Service Letter No. 368

TO:Distributors, Dealers, Certified Service Centers and OwnersSUBJECT:Lycoming Service Instruction No. 1049 dated December 29, 1961MODELS AFFECTED:PA-23 and PA-23 "160" Apaches, PA-24 "250" Comanches --
incorporating Lycoming O-320, O-360 and O-540 series

DATE:	December 29, 1961	Service Instruction No. 1049 Approved by FAA
SUBJECT:	Lightweight Diaphram Fuel Pump for Direct	Drive Engines
MODELS AFFECTED:	Lycoming O-235 Series, O-290 Series, O- Series and O-540 Series Aircraft Engines	-320 Series, O-340 Series, O-360
TIME OF COMPLIANCE:	At Owner's Discretion or Anytime Fuel Pum	p Must Be Replaced

Four Cylinder Pump

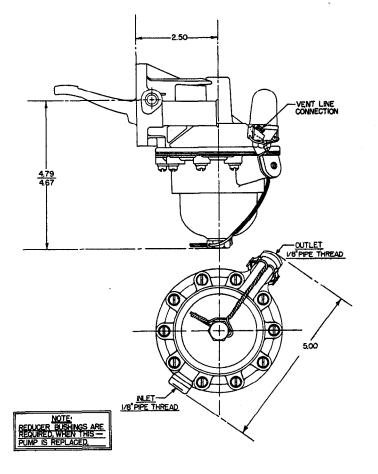
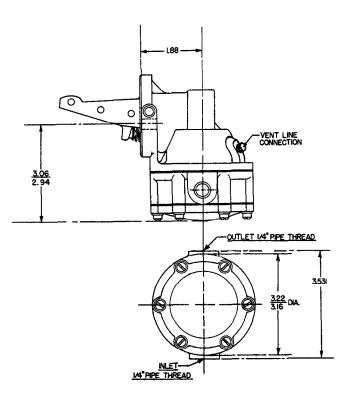
Since the new pump is smaller, it may be necessary for owners and operators to either replace or rework the fuel inlet line to the pump and fuel outlet line from the pump to the carburetor. This will depend on the type of installation, solid or flexible lines, etc. On Page 2 is an outline of the new and older style pumps which shows the difference in pump sizes. When installing the pump, tighten the two 3/8" capscrews to 250 inch pounds.

New Lightweight Pump Replaces Either Pump Shown Above

A redesigned diaphram type fuel pump (Lycoming P/N 74060) is now being incorporated on all production engines of the above listed models. This new pump is both smaller and lighter in weight than the pumps it replaces. The attaching capscrews are shorter and will not have a tendency to become loose causing oil leaks. To install redesigned pump, order parts listed below under "Parts Required".
